MEMORANDUM

Subject Hanover Weston – 518 South Avenue – Weston, MA
Chapter 40B Project Traffic Peer Review

Figure 1: Diagram of Intersection Sight Distance Triangle (FHWA)

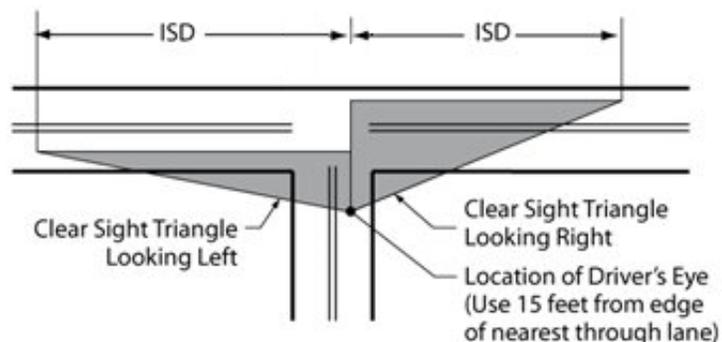
- Given the terrain constraints looking left, the applicant should provide a more detailed analysis of both Stopping Sight Distance (SSD), which is the length of roadway visible to the motorist to a fixed object, and Intersection Sight Distance (ISD), which calculates sight lines visible for the exiting vehicle. In short, SSD allows a driver on South Avenue to detect and take corrective action (i.e., stop) due to a stationary object in its path (i.e., an exiting vehicle). ISD ensures adequate distance for visibility of an approaching vehicle on South Avenue for a driver exiting from the site driveway. **It is critical that both SSD and ISD be met to ensure adequate sight lines for drivers exiting from the site and for drivers traveling along South Avenue.** Requirements and detailed measurements should be provided for both SSD and ISD looking in each direction from each proposed site driveway.

- It is assumed that measured sight distance of 360 feet represents SSD. This should be more clearly stated in the TIAS.
- The proponent should provide sketch plans clearly showing the measured sight lines and ISD in both directions. Exhibits provided in Appendix F of the TIAS do not adequately show all sight triangles.
